**TOWN OF GLASTONBURY
BID NO. GL-2014-14**

**TRYON STREET DRAINAGE PHASE 1
DATE AND TIME REQUIRED: JANUARY 14, 2014 AT 11:00 AM**

**ADDENDUM NO. 1
JANUARY 7, 2014**

MANHOLE FRAME
AND COVER

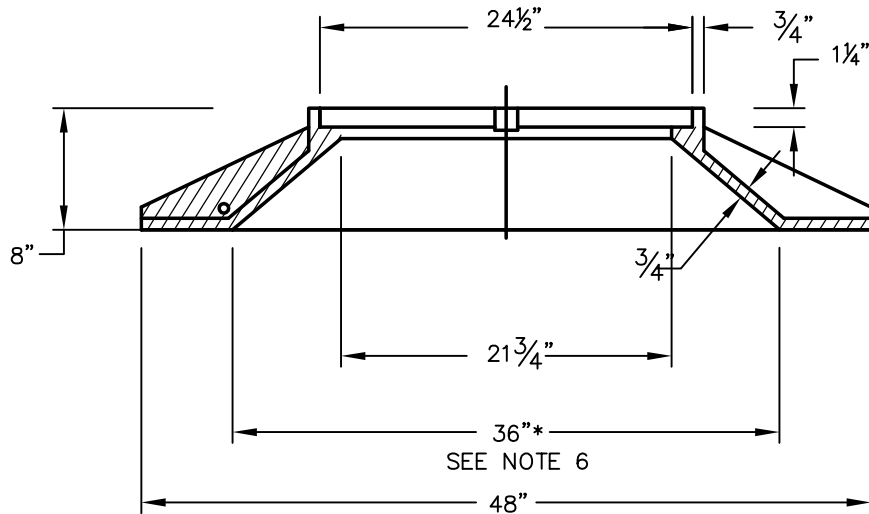
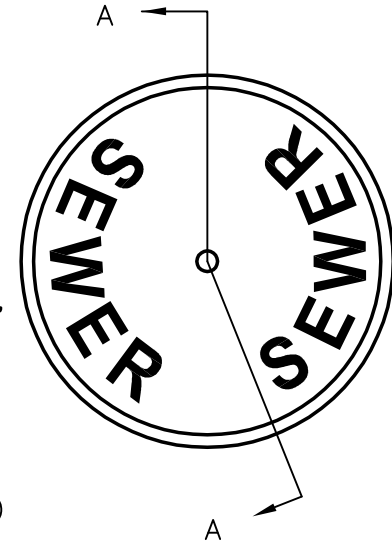
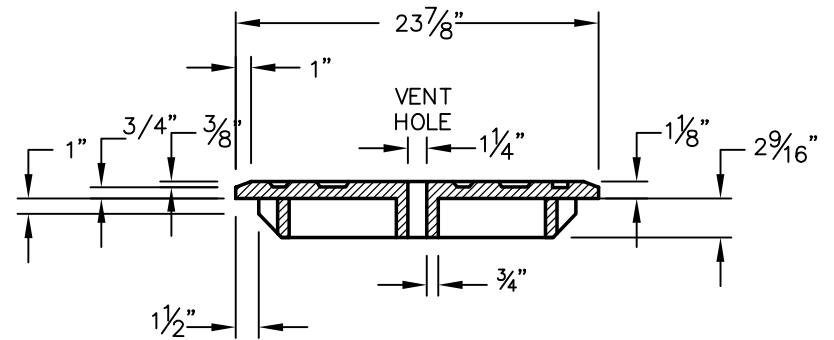
Q1-1:	Do all manholes have to be a minimum of 7' diameter or is the diameter determined by the size and configuration of pipes?
A1-1:	Manhole G-2 shall be a 6-foot diameter manhole.
Q2-1:	The manhole detail on Plan Sheet 5 references "Plate 33" for the manhole frame and cover requirements. Where can this detail be found?
A2-1:	Plate 33 is attached to this addendum.
Q3-1:	The 36-inch pipe will not fit in outlet structure G-1 as designed based on the flow line and top of frame elevations listed on the plans. Please clarify.
A3-1:	The top of frame elevation of this structure can be fit in the field to accommodate the 36-inch pipe.
Q4-1:	Does the Town of Glastonbury have a standard bid bond form or is the AIA form acceptable?
A4-1:	No, the Town of Glastonbury does not have a standard bid bond form. The AIA form is acceptable.
Q5-1:	Does the bid item for Bid Item 19 Modified Riprap include the geotextile fabric?
